**Meridian Airport Authority, Dean Aircraft Services
Hangar Additions & Alterations**

ADDENDUM NO. 4

TO: All Bidders on the Above Referenced Product
FROM: Davis Purdy Architects, PLLC
DATE: March 17, 2020
SUBJECT: **ADDENDUM NO. 4**

1 PARTIAL POWER PLAN - FIRST FLOOR - PART B
E-202 Scale: 1/8" = 1'-0"

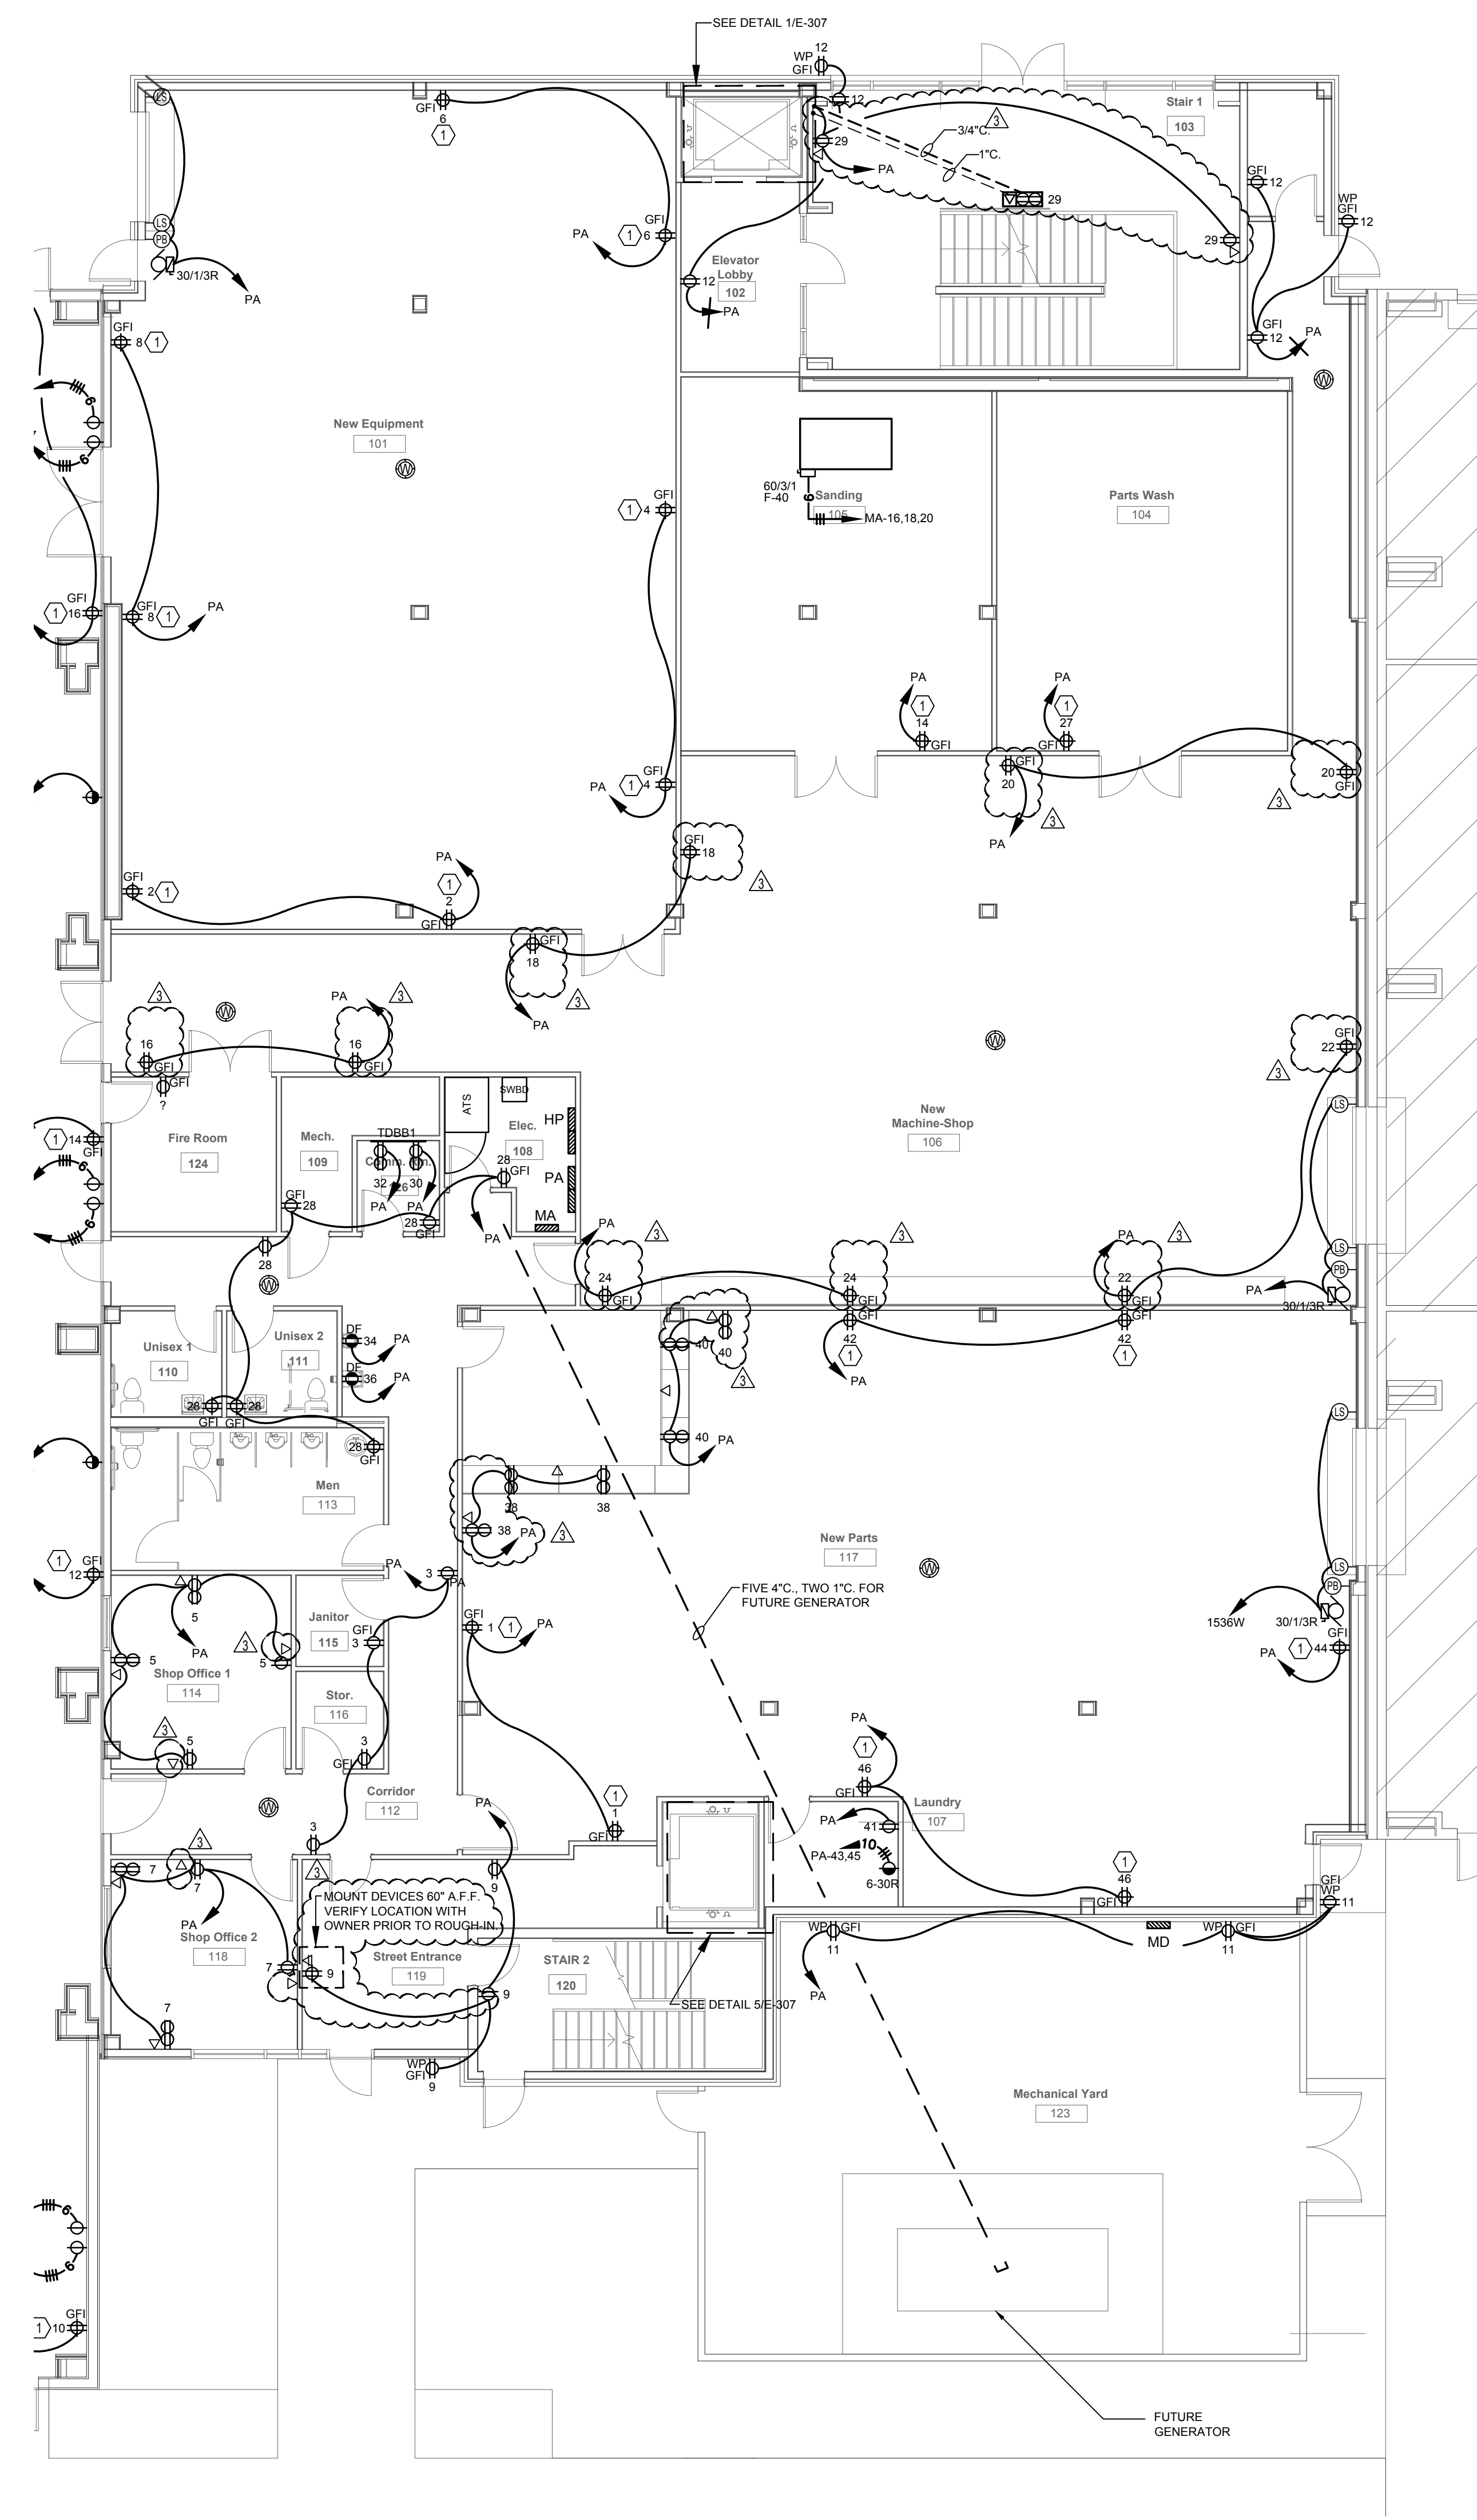
- g. E-105 PARTIAL LIGHTING PLAN 3RD FLOOR**
 - i. Modified exterior fixtures controls.
 - h. E-202 PARTIAL POWER PLAN 1ST FLOOR PART B**
 - i. Modified Receptacle mounting heights.

- ii. Added Data Devices.
 - iii. Added Data and Power to Stair 103 & Street Entrance 119.
 - iv. Added Addition Data and Power to New Parts 117.
 - i. E-204 PARTIAL POWER PLAN 2ND FLOOR PART D**

1 PARTIAL POWER PLAN - SECOND FLOOR - PART D
E-204 Scale: 1/8" = 1'-0"

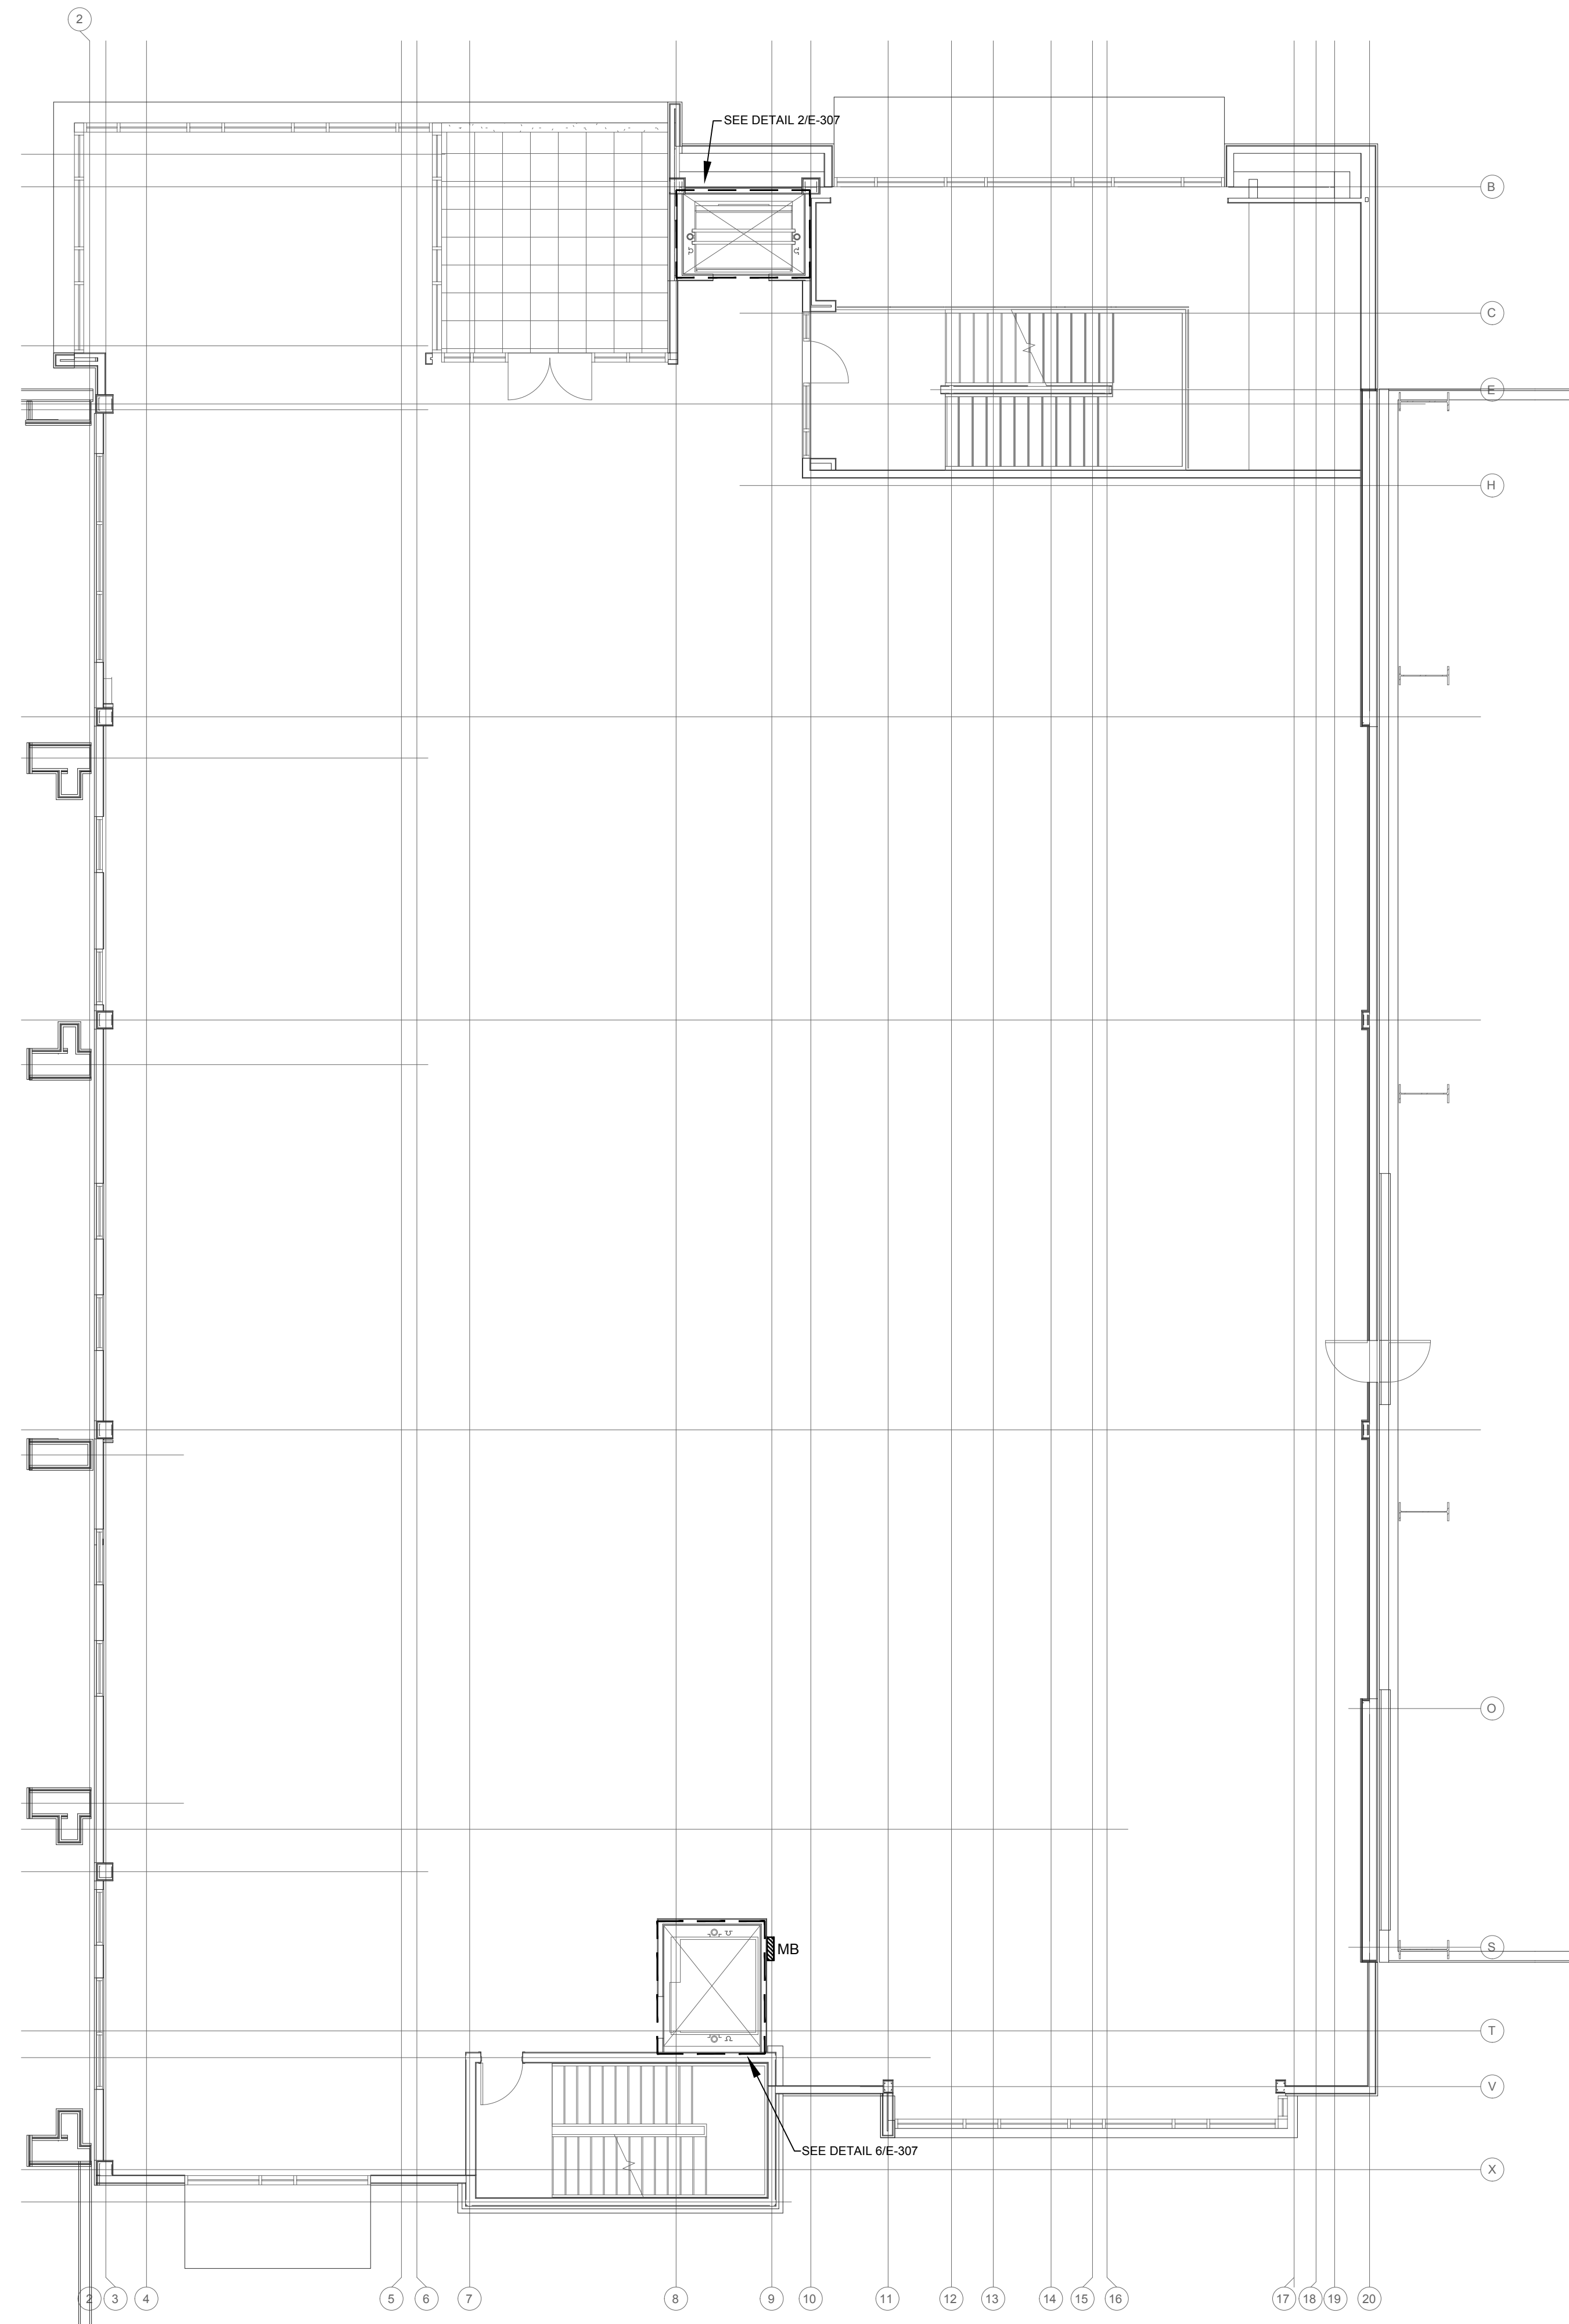
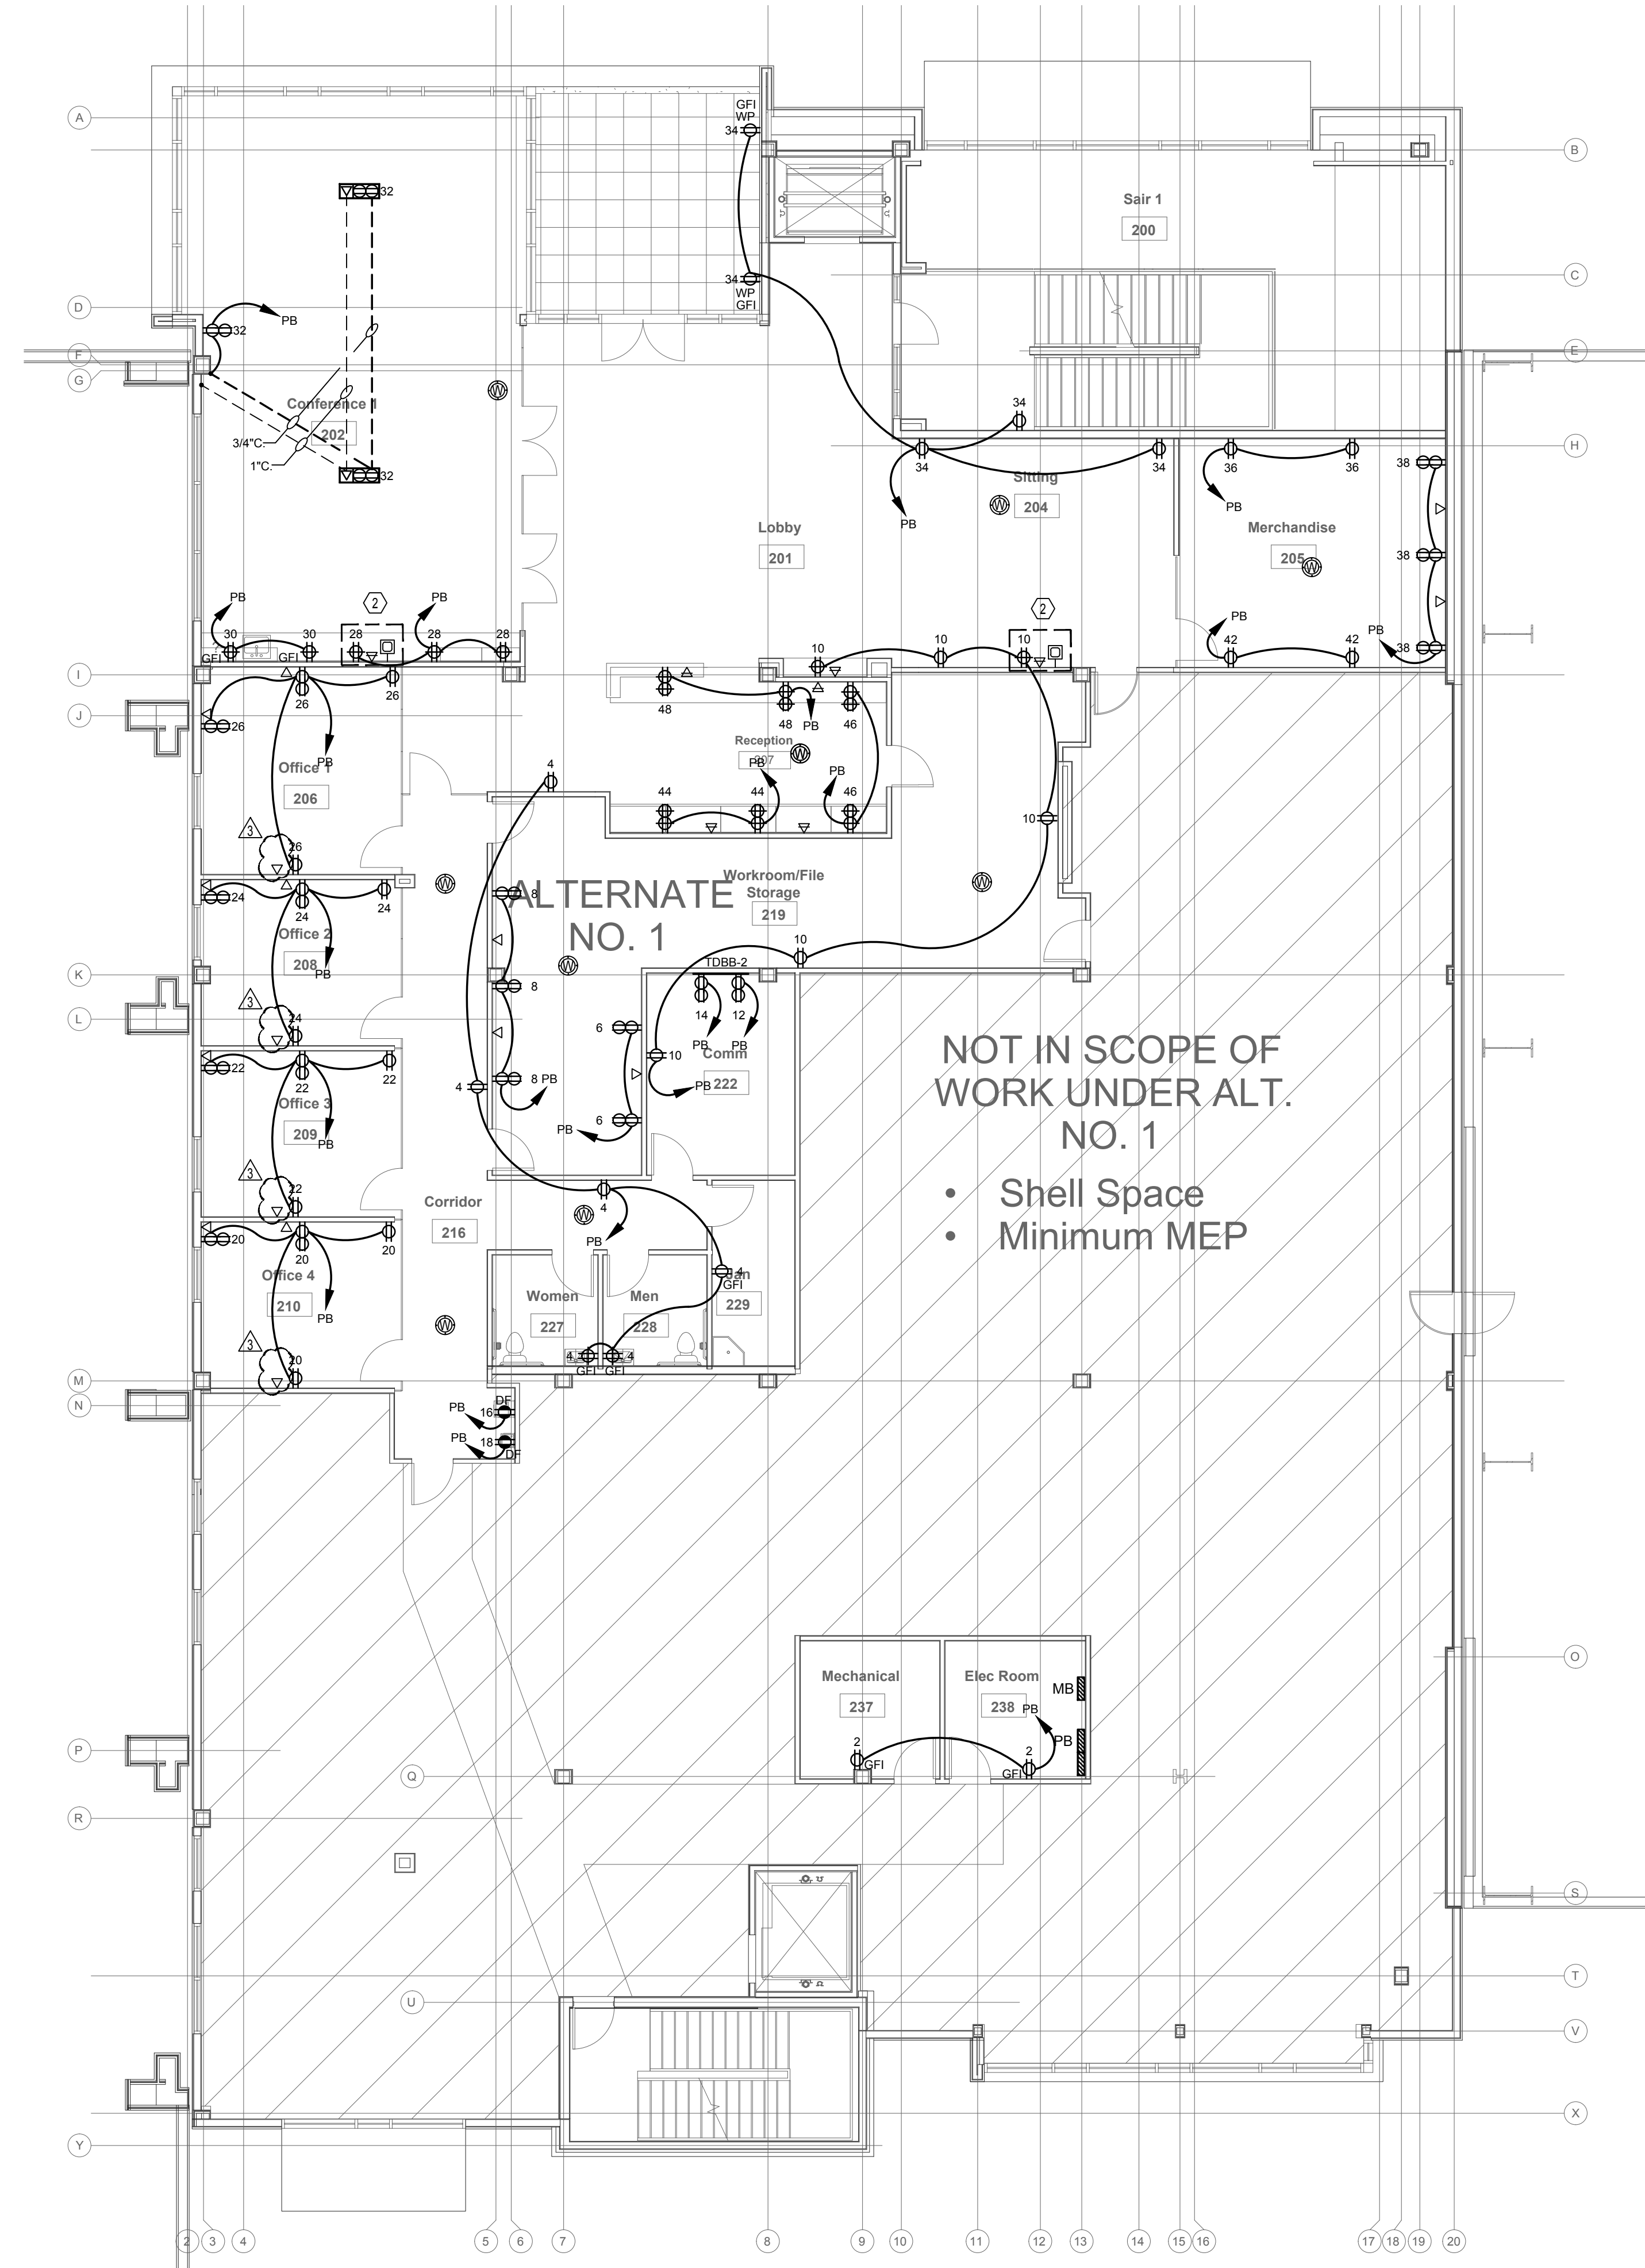
- i. Added Data Devices.
 - j. E-205 PARTIAL POWER PLAN 2ND & 3RD – FLOOR PART D & E**
 - i. Added Data Devices.
 - ii. Modified Power and Data layout in Log Room 231.
